Duane Arnold Energy Center  
Docket No. 50-331  
Renewed Facility Operating License No. DPR-49

NextEra Energy Duane Arnold, LLC's Six-Month Status Report in Response to June 6, 2013 Commission Order Modifying Licenses with Regard to Reliable Hardened Containment Vents Capable of Operation Under Severe Accident Conditions (Order Number EA-13-109)

NextEra Energy Duane Arnold, LLC's Six-Month Status Report in Response to  
June 6, 2013 Commission Order Modifying Licenses with Regard to Reliable Hardened  
Containment Vents Capable of Operation Under Severe Accident Conditions  
(Order Number EA-13-109)

Attachment A – Updated Layout of Proposed HCVS

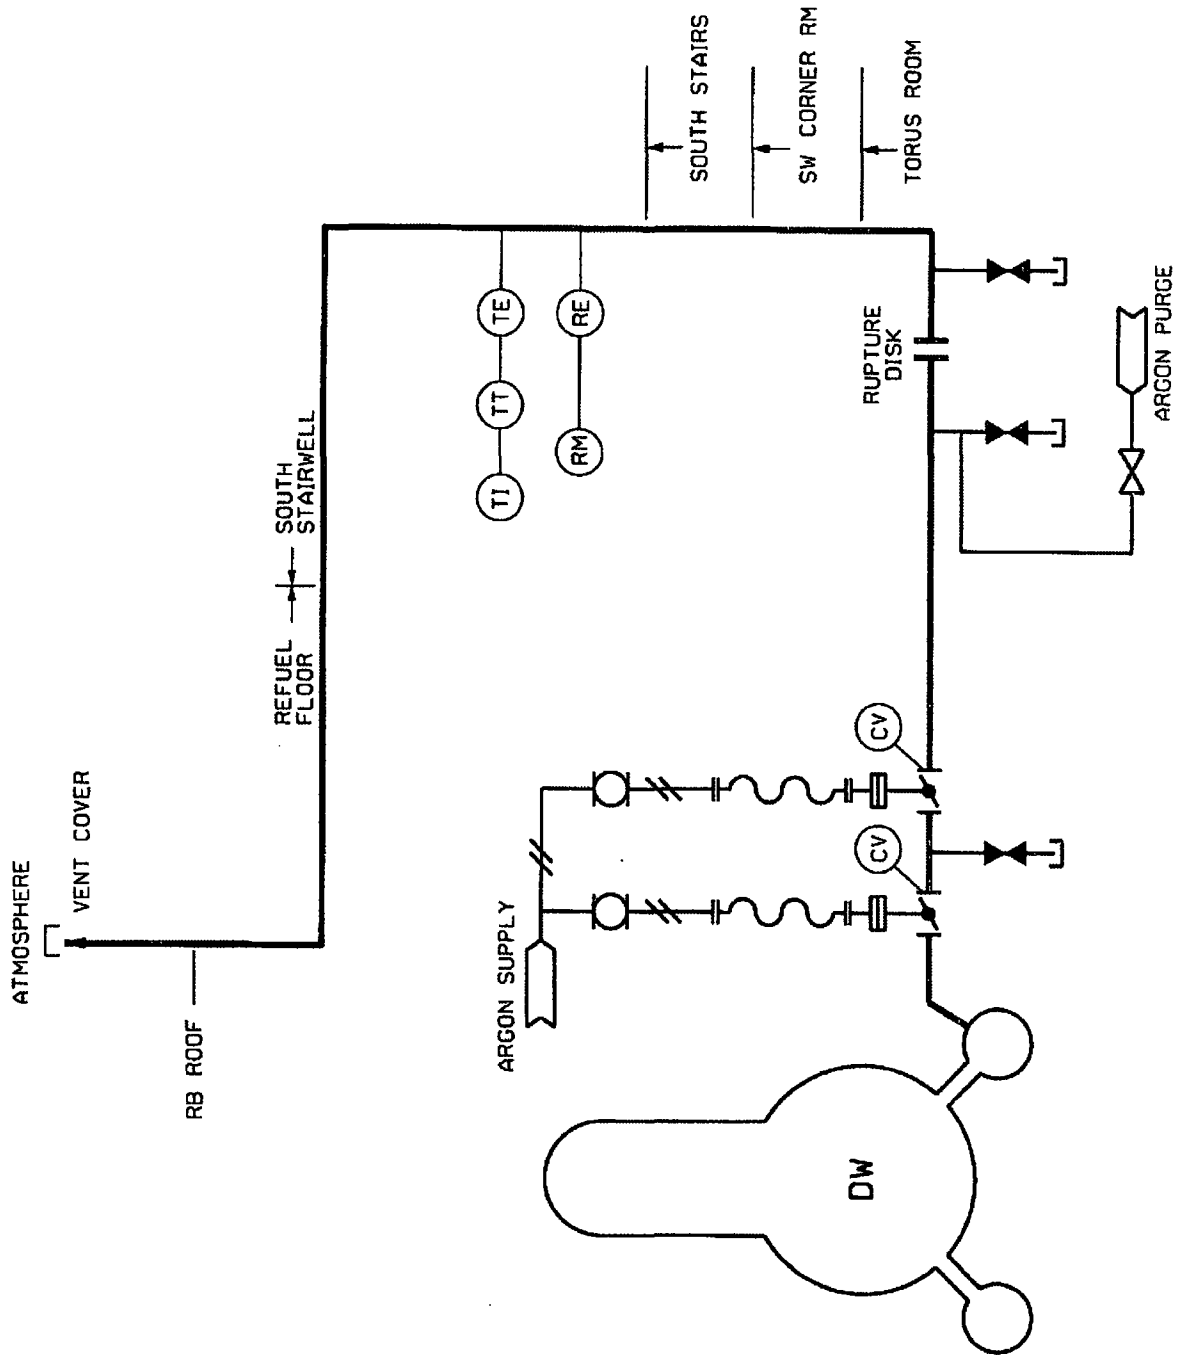
- 2) The routing of the new containment hardened vent system (HCVS) piping has changed from utilizing an existing containment penetration that supports normal venting to the Standby Gas Treatment System to using an existing spare penetration off the suppression pool. The vent piping will be routed into the south reactor building stairwell, up to the refuel floor and out the reactor building roof, reference Attachment A.

- 3) The HCVS piping will contain two new primary containment isolation valves and a new rupture disk as shown in Attachment A.
- 4) Attachment B is an updated listing of the HCVS instrumentation. It should be noted that the Interim Staff Evaluation (ISE) inadvertently listed a vent pipe process pressure indicator which will not be part of the Duane Arnold design.
